Report to Development Permit Panel

To: Development Permit Panel **Date:** November 21, 2014
From: Wayne Craig **File:** DP 14-663759
Director of Development
Re: Application by Amar Sandhu for a Development Permit at 7400, 7420 and 7440 Railway Avenue

5. DP 14-663759 – 14-UNIT TOWNHOUSE DEVELOPMENT

CONVERTIBLE UNIT PLAN

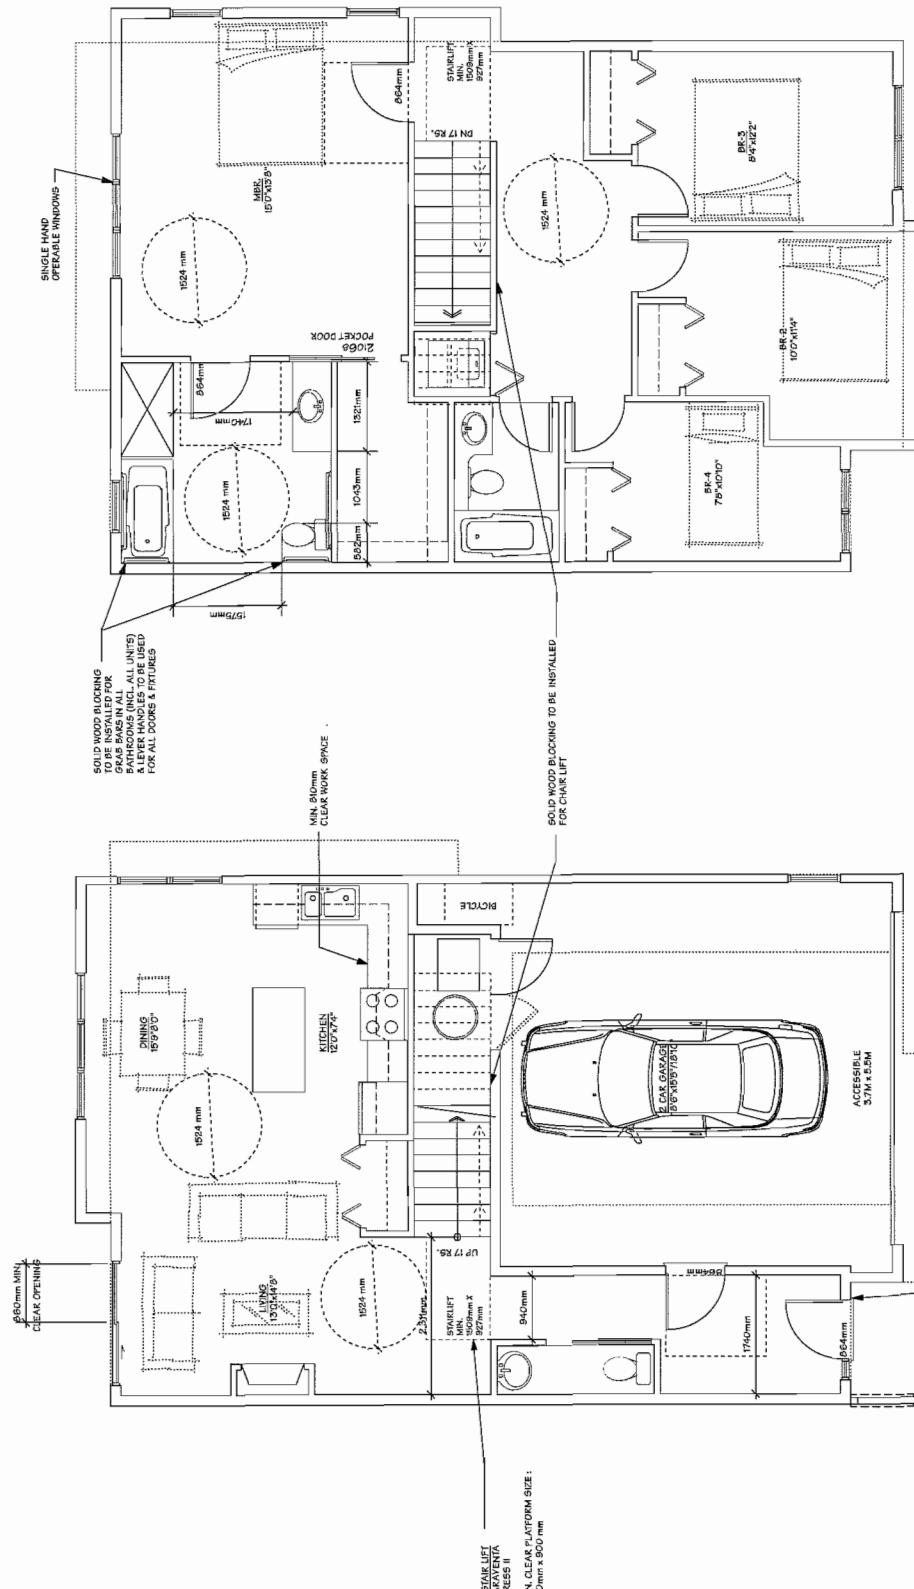
- appreciate the provision of a convertible unit in the project; ensure that the size of the bottom stair lift platform is adequate;

Minimum clearance space of 750mm x 600mm platform shown at the bottom of the stairs of convertible unit.
